**Re: BCA STANDARD REVIEW OF DESIGN PLANS
52-62 May Road, Narraweena, NSW**

COMPLIANCE ASSESSMENT

PROPOSED MIXED USED
DEVELOPMENT
52-62 MAY ROAD,
NARRAWEENA NSW

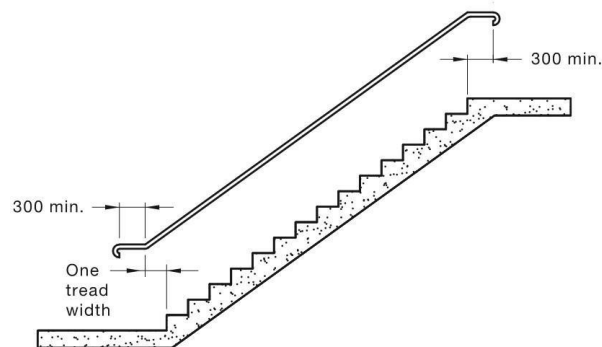
The width on the first and 2nd floor to enter the lift must as minimum 1240mm is required. The grates on the ground floor entry from the courtyards might also be a non-compliance. An access consultant is to access the drawings for compliance.

Further details to be provided for assessment to an access consultant.

Figure 1 – AS 2890.6 bollard location below

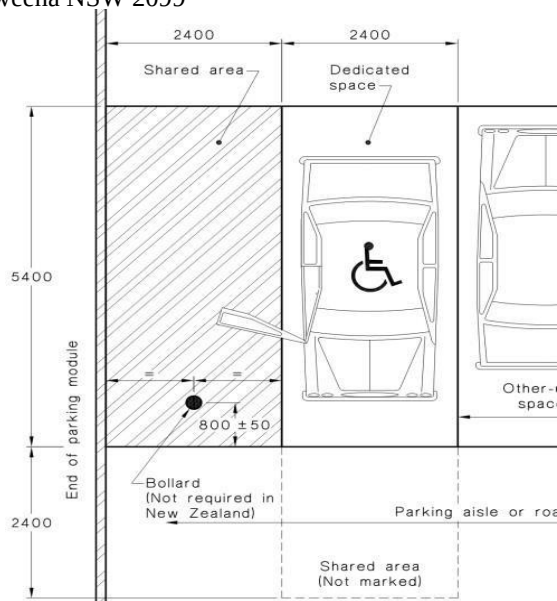
The proposed accessible carparking space is required to comply with AS/NZS 2890.6.

A bollard is required within the shared zone to comply with Clause 2.2.1(e) of AS/NZS 2890.6-2009, see figure 1 below.
